WAIVER/CONCESSION

1. DOCUMENT IDENTIFICATION		1.1. Identification of customer: Rolls-Royce Canada Limited		Supplier #:		1.3. Document reference number Customer #: 210256950		1.5. Category: "GE-3656", CAT 2

2.1. Model of product/program: I TRENT		2.2. Part number: TRN14806		Drawing Issue:		2.4. Part Serial Number/Batch/Effectivity Number/Lot Number: (see box 3)		2.5. Quantity: 1	
Contract Number:		2.3. Part Description: CASE, INLET, ASSY OF		2.6. Product Number:		2.7. Work/Purchase Order Number:		2.8. Assembly Serial Number:

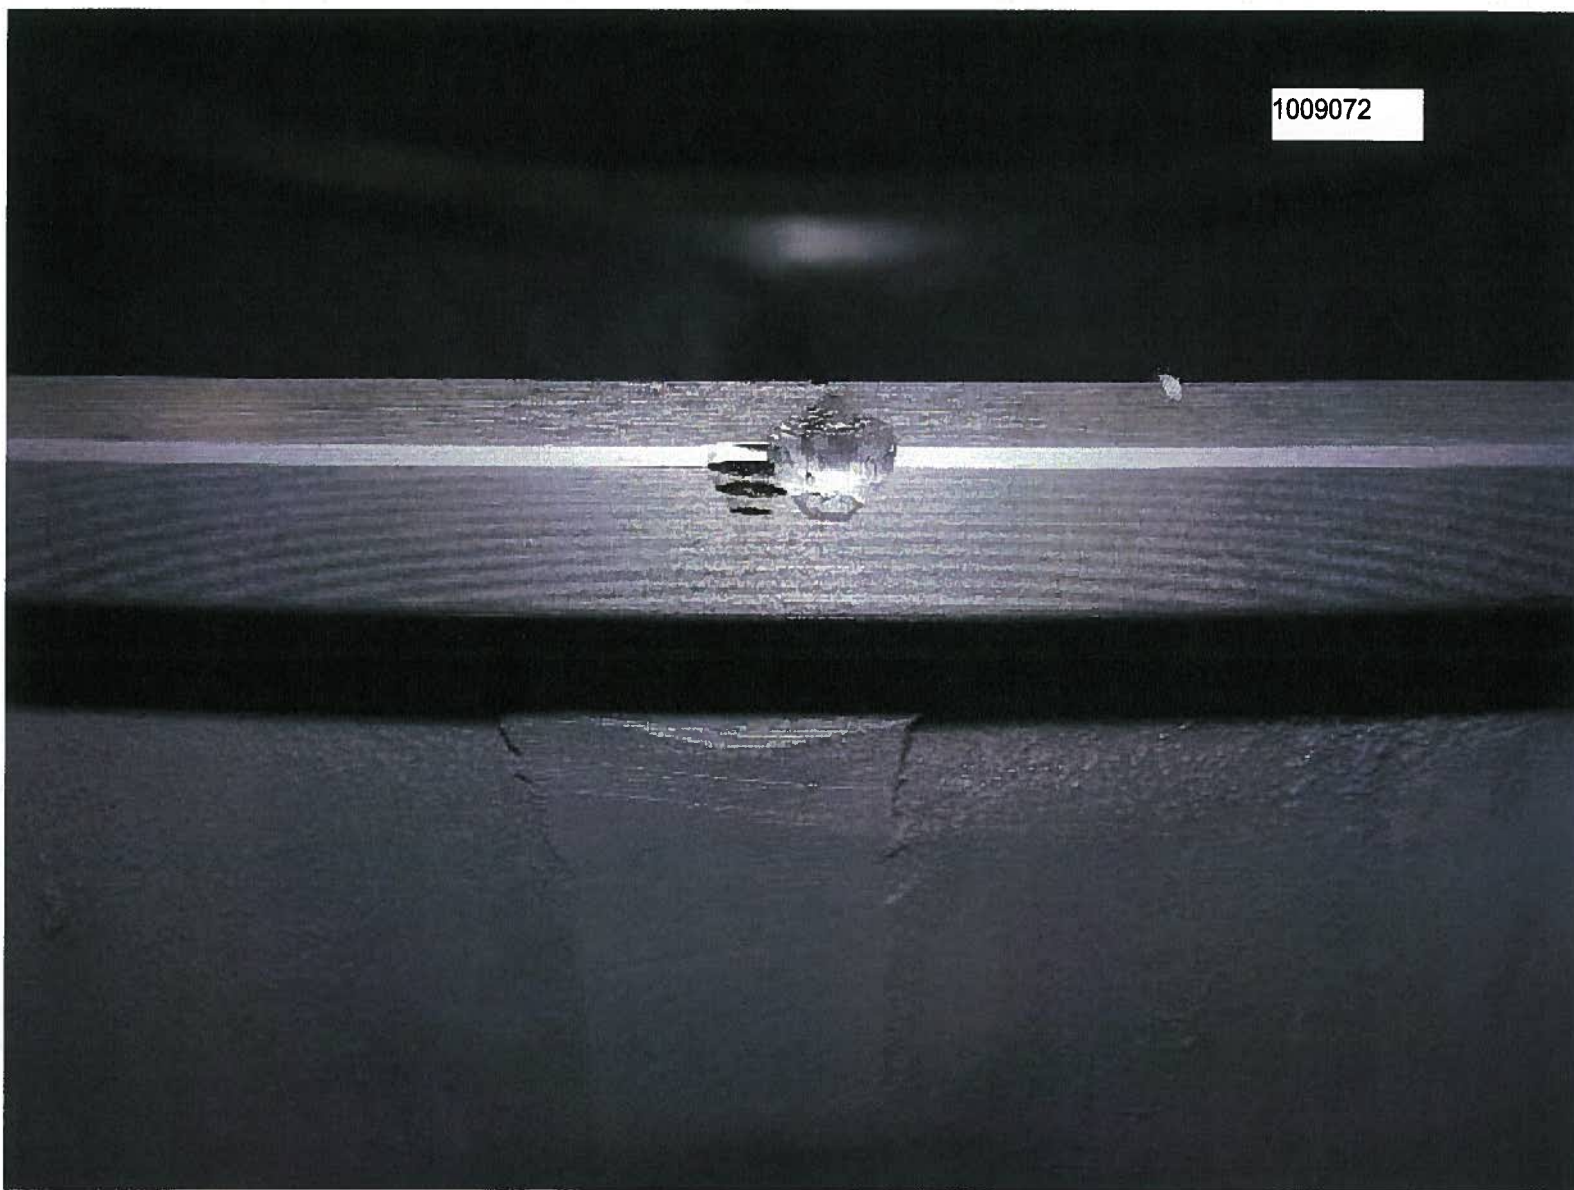
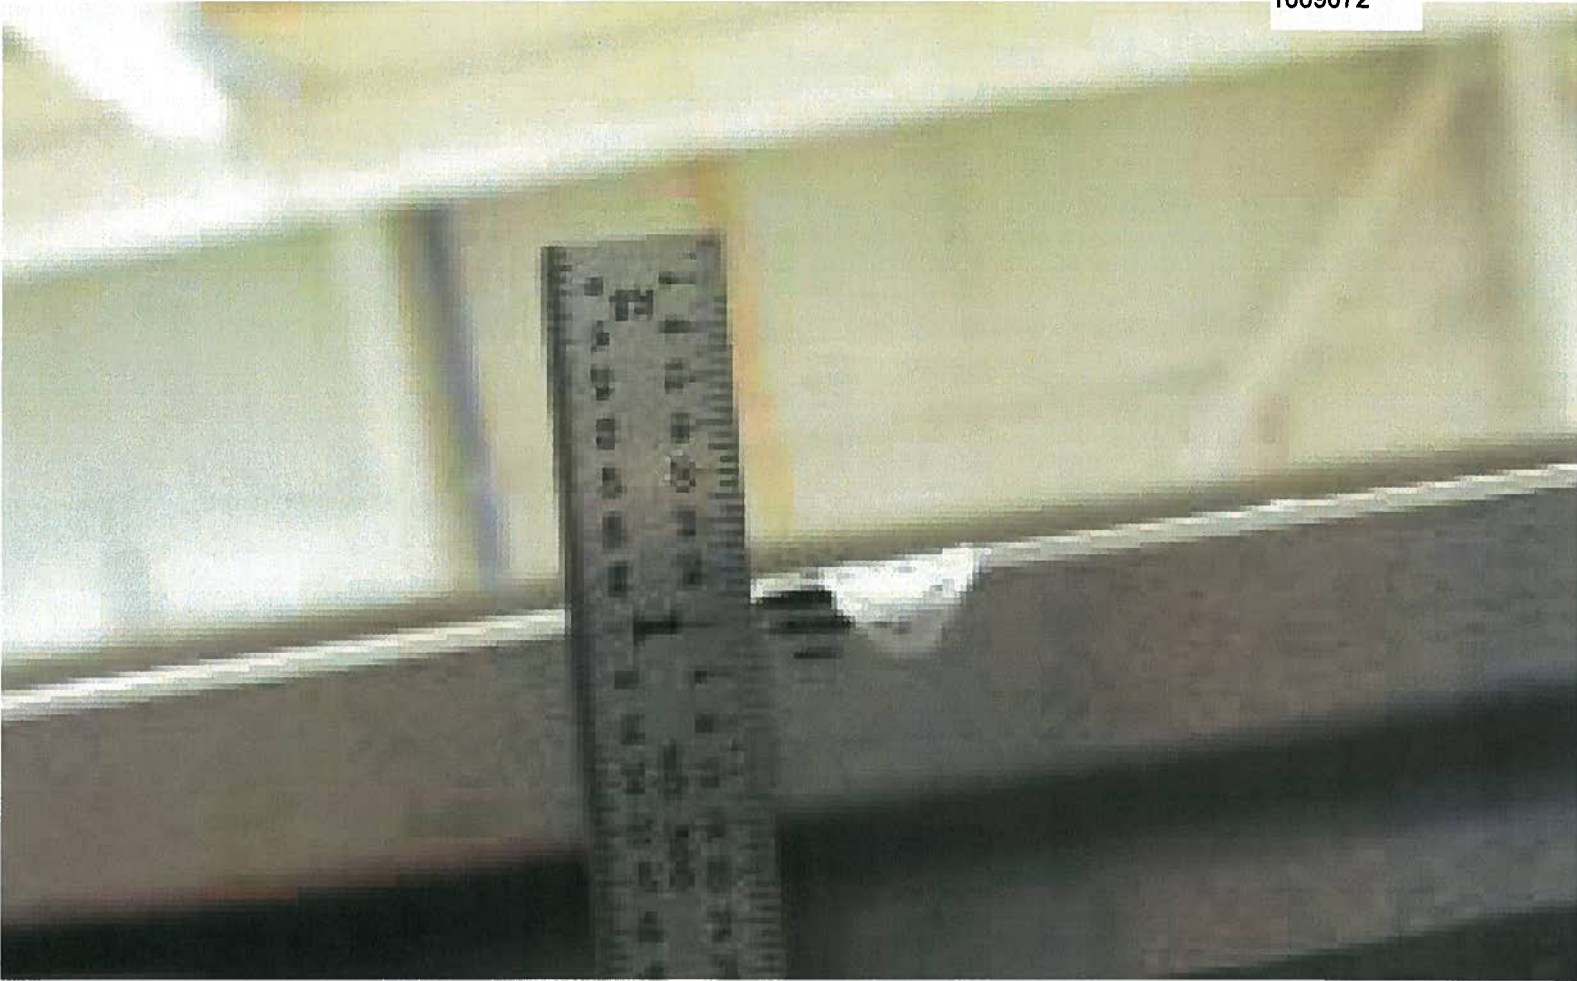
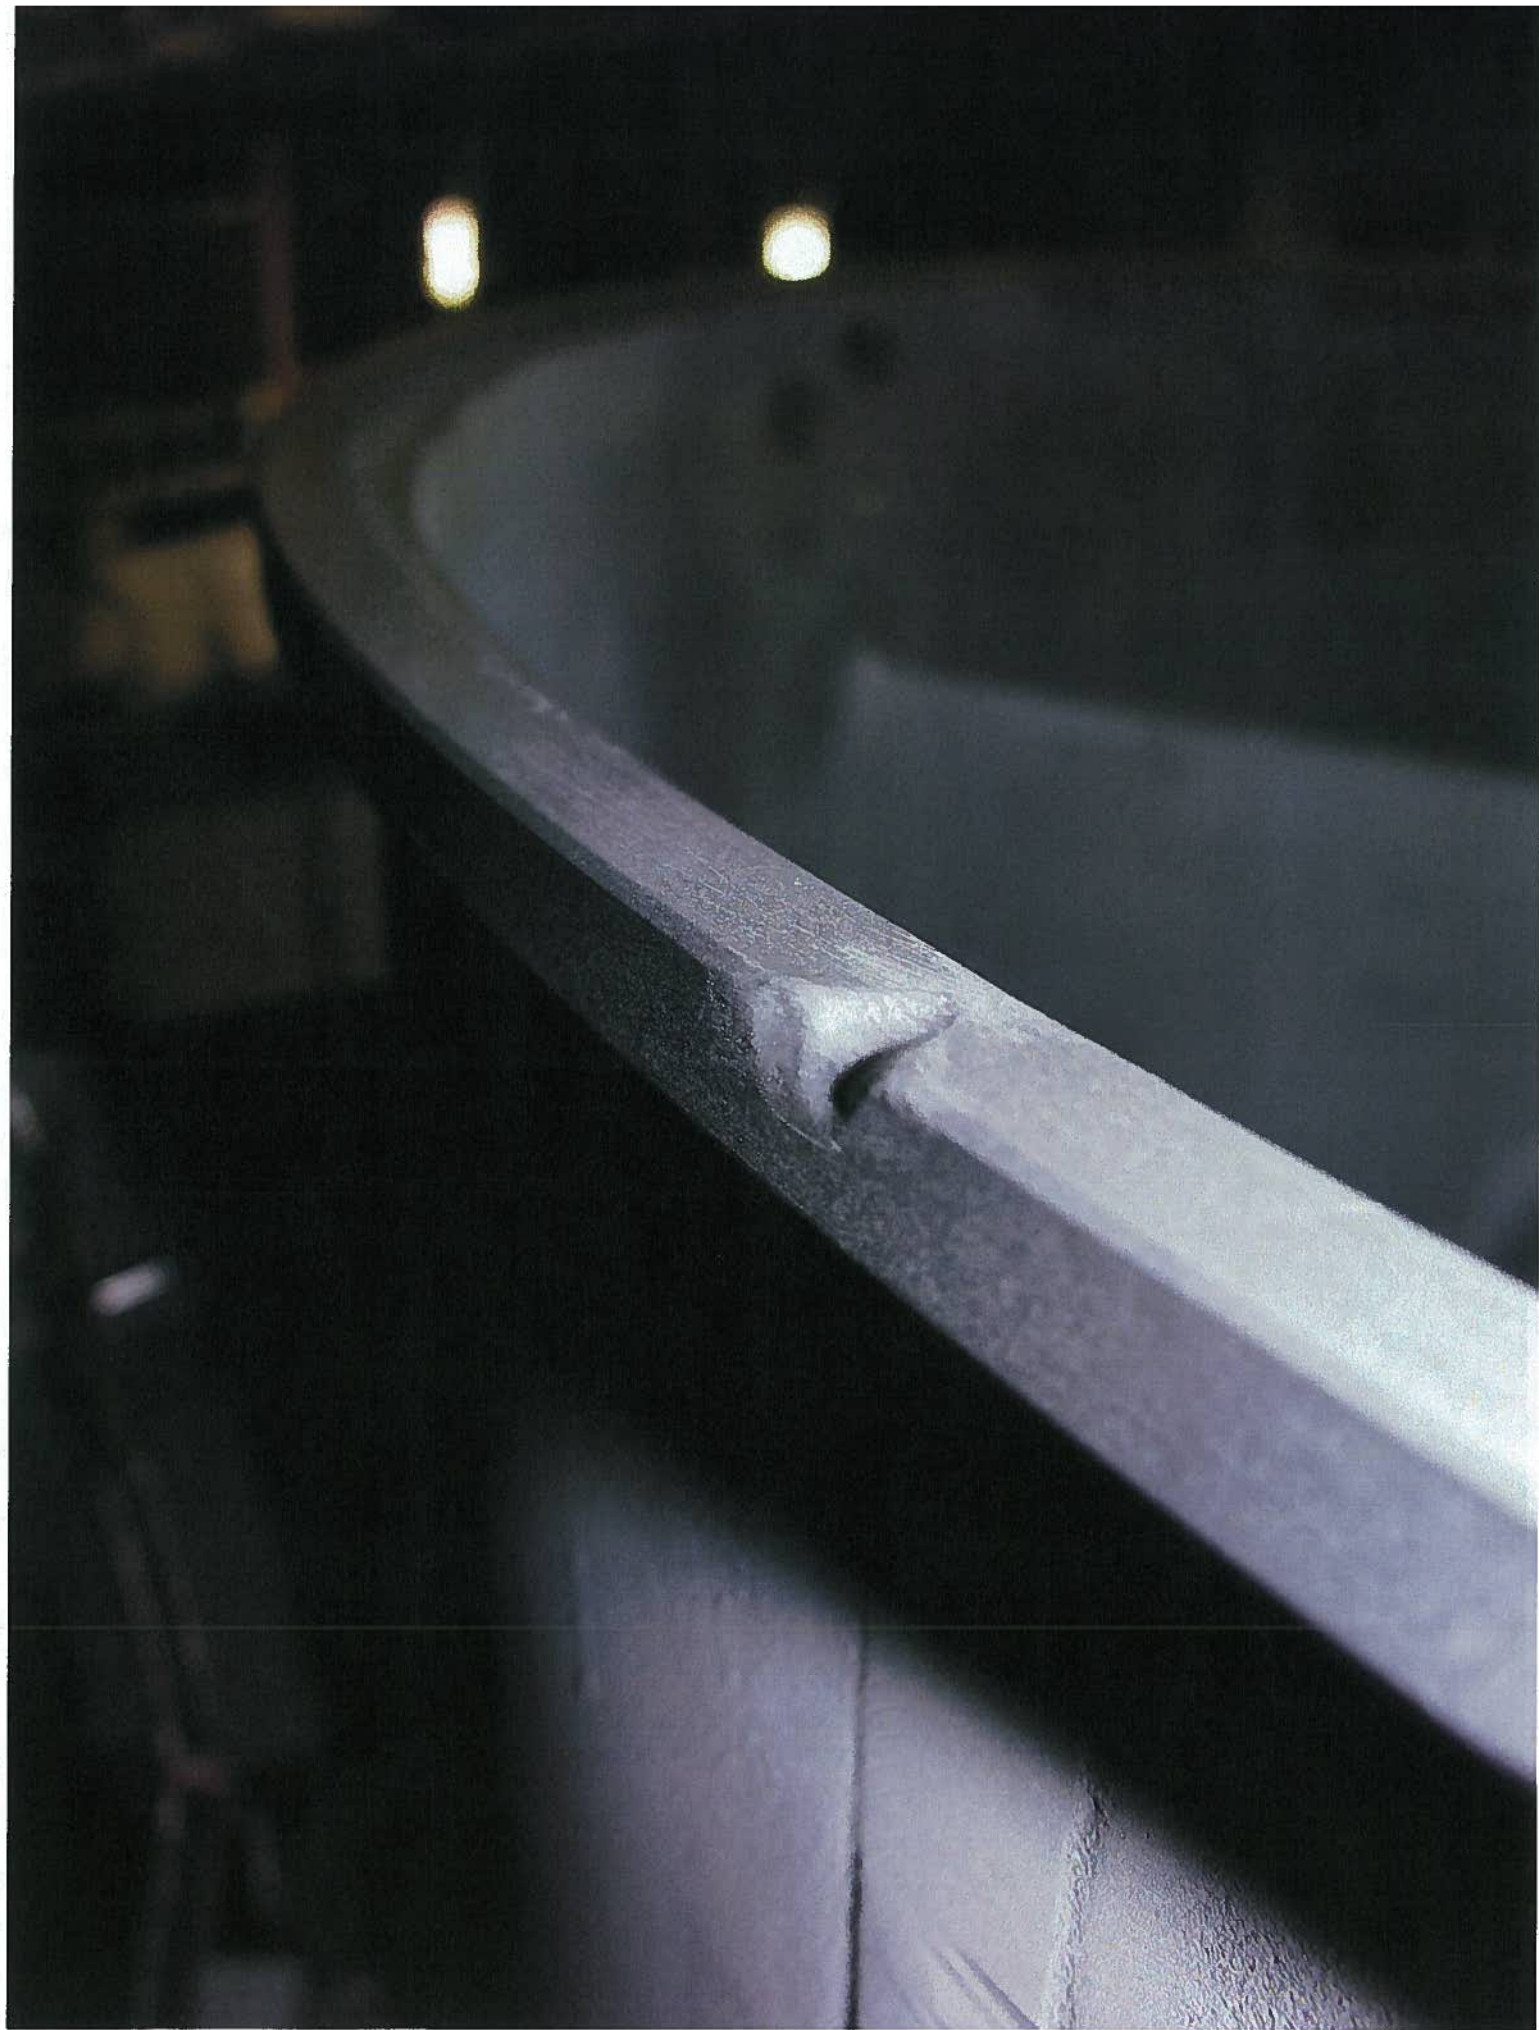
2.9. Assembly Drawing Number:	
3. DESCRIPTION OF NONCONFORMITY		5. DISPOSITION OF NONCONFORMITY							
Engine 056 Notification 210256989		5.1. MRB/Design Decision:							
The Inlet Case Assy was found damage on the external flange lip at BDC. Damage measures approximately 0.400in long by 0.360in wide by 0.240in deep. The damage occurred as the Engine was installed in the Transportation stand.		ACCEPTABLE CAT 2 FOLLOWING PROPOSED REPAIR. MARK "GE-3656" NEXT TO PART NUMBER.							
Request permission to polish and locally cracktest the damage as per scheme EFRS3253.		Quality Decision:							
Previous Submissions of a similar nature:		Previous Submissions to actual item:
